From: "Donald E. Vanover" <DEVanover@erineng.com>
To: <dxw@nrc.gov>, <rlp3@nrc.gov>
Date: 7/16/03 11:43AM
Subject: Draft Dresden SAMA RAI Responses

Bill Maher requested that I send the Draft Dresden SAMA RAI responses to you directly.
See attached.

RAI 1

**Figure 3-1
Typical Dresden Level 2 Containment Event Tree**

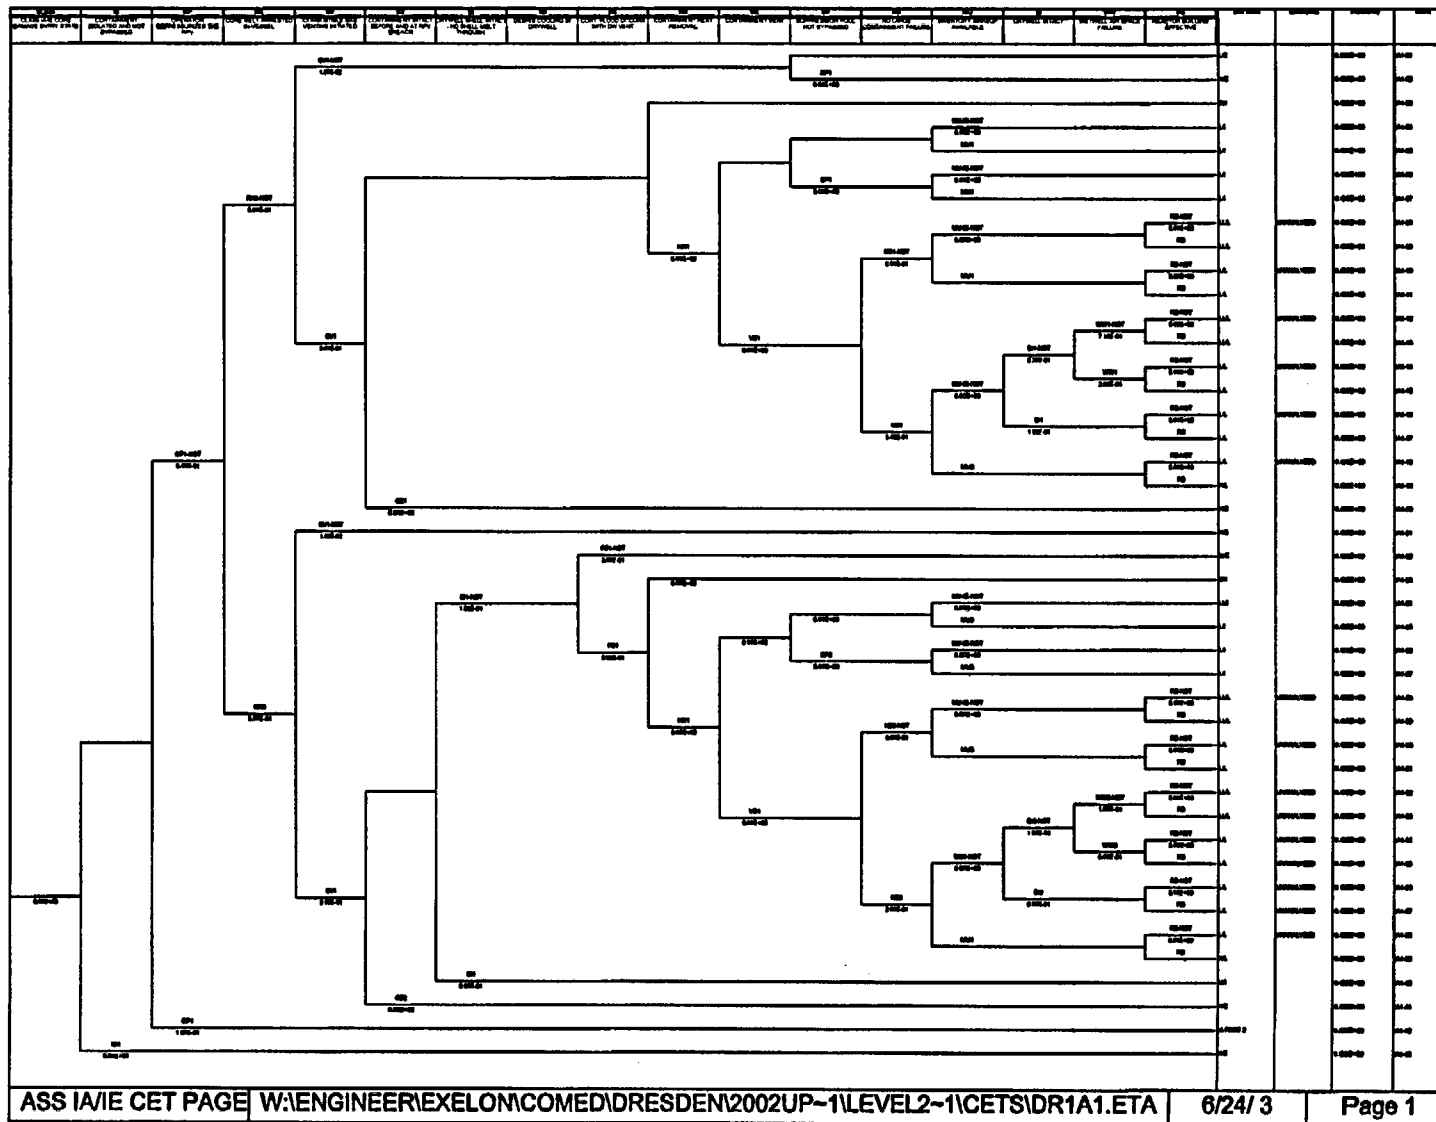
"[Provide] each release (consequence) category used in the Level 3 analysis (as listed in Column 1 of Table 4-5), the specific source terms used to represent each release category, and a containment matrix describing the mapping of Level 1 results (plant damage state frequencies) into the various release categories."

The CET calculation for each cutset uses Boolean logic and fault tree models to process the incoming Level 1 cutsets to ensure that the resulting Radionuclide release frequencies properly reflect the impact on release magnitude and timing of the containment and containment mitigation systems. A typical CET (for Accident Class 1A) is provided in Figure 3-1.

In summary, the Level 1 end states do not translate directly into release categories. Each Level 1 accident sequence (all of the cutsets) is transferred into the appropriate CET. The CET is then used to determine the resulting frequency for each radionuclide release end state from each incoming cutset. This is typical of a full Level 2 for a binned fault tree model. This approach does not involve a matrix that relates Level 1 sequences directly to Radionuclide end states.
